**Bridgeville Town Hall – Feasibility Study
101 North Main Street,
Bridgeville, DE 19933**

GMB File No. 250281.00
February 25, 2026 – 9:30 a.m. – 10:30 a.m.

PROGRESS MEETING

Site Plan:

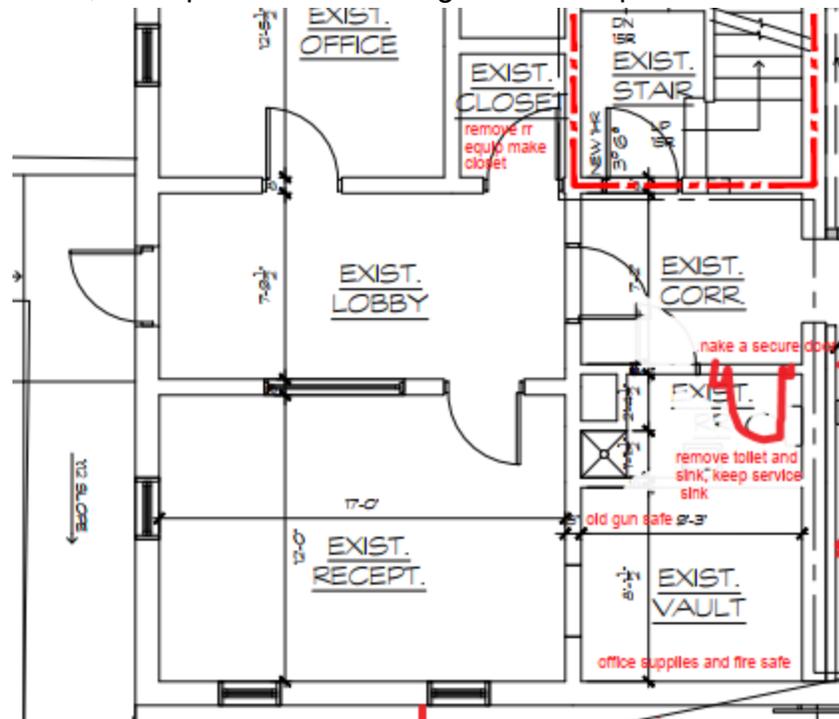
- 1) Proposed plan was reviewed conveying the addition of new building addition onto existing.
- 2) The existing building, addition, parking, and other miscellaneous features on site were under the allowable impervious areas. No wellhead protection zone located on this property.
- 3) Newly renovated parking lot would be under the required number of parking spots with the addition. 55 existing parking spots are provided, in comparison to the 62 parking spots required by zoning code with the new addition. Additional parking spots could be considered near conjoined town hall and police entrance. Ultimately at Town's discretion if they can forgo the requirements.

Building:

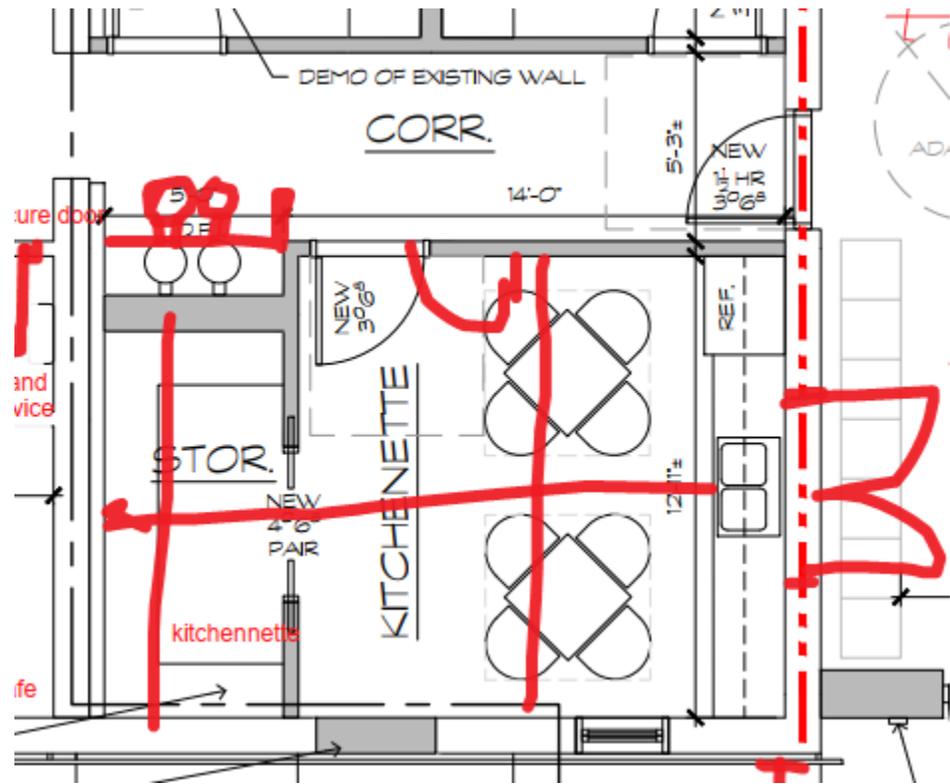
- 1) Of the two schemes reviewed, the Town was overwhelmed by the two storied addition and preferred the consideration of single story only (scheme A).
 - a) Town preference for the single-storied telescoping addition. In favor of cathedral ceiling with dormers open to the commission chambers. Note to incorporate acoustic baffling for noise reduction.

- b) Still provide consideration for future second floor. Single story roof structure cannot accommodate heights. Set bearing elevation of roof at similar elevation of adjacent existing second floor, for future roof removal and installation of second floor structure.
- 2) Secondary path to existing receptionist
 - a) Currently only access to receptionist is through the lobby, no secondary means of egress. Concern of entrapment (i.e. hostile resident in lobby), or inability to access other features of the town hall without passing through.
 - b) Remove existing toilet and sink off the existing corridor besides stairs, and open wall at existing vault. Incorporate a secure door.

- 3) Flip kitchenette and storage in newly reconfigured space.
 - a) Back kitchen countertop and cabinets against vault and storage towards commissioner’s chambers. Storage to open to commissioner’s chambers.

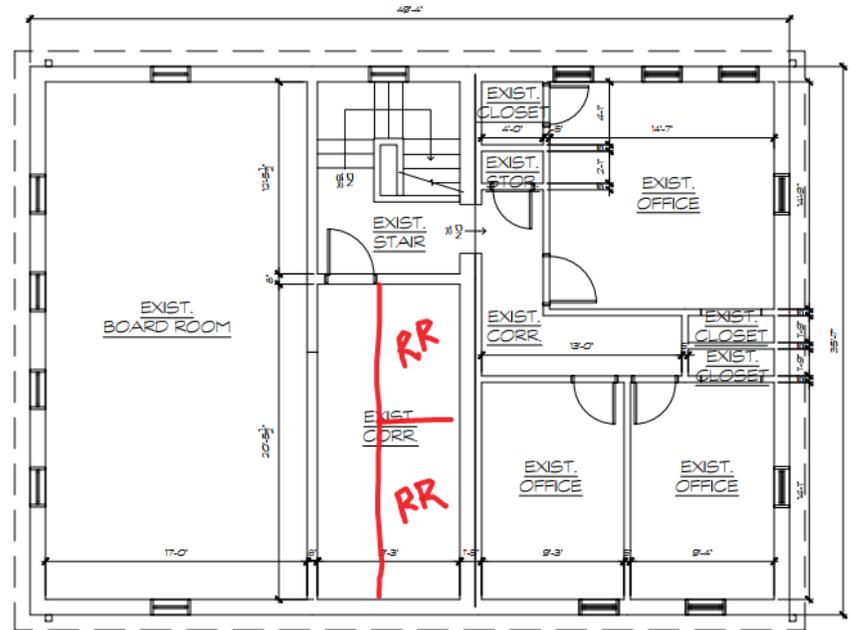
- b)
- 4) Reconfigure seating layout in commissioner's to recoup lost seating.
- 5) Revisit plumbing count.
 - a) Provided current size of existing building and with new single floor addition; only need a min. of 5 waterclosets (min. 2 female, 2 male, and 1 unisex) and a min. of 3 lavatories (min. 1 female, 1 male, and 1 unisex).
 - b) Exist. closet off lobby is also a restroom with toilet and sink. Plumbing fixtures to be removed and converted into a closet.
 - c) Current existing restroom off stairs to remove watercloset and lavatory fixtures for walkthrough.
 - d) Integrate two existing restrooms at second floor.

- i)
- e) Min. 1 service sink required (to remain at current location), and provision of 1 drinking fountain. Question was asked if a plumbed drinking fountain can be forgone for a bottle water drinking fountain. This is dependent upon municipal inspector, and suggest leaving plumbed fountain.

- 6) Elevator was discussed amongst the workgroup, and in favor for elevator at the loss of the kitchenette, new restrooms, and storage spaces. Final decision was to avoid elevator. Must prioritize the newly renovated meeting area, supporting restroom space, a functional kitchenette and storage.

- a) Note, workgroup had a hard time understanding how the existing portions of the town hall was renovated for kitchenette and bathroom use. Possible dash-in former portions to be removed to illustrate integration on plan.

- 7) Consideration for removing the newly proposed ramp. Leave as second means of entry into council chambers without having to go through lobby and pass through other points (i.e. stairs to second floor).
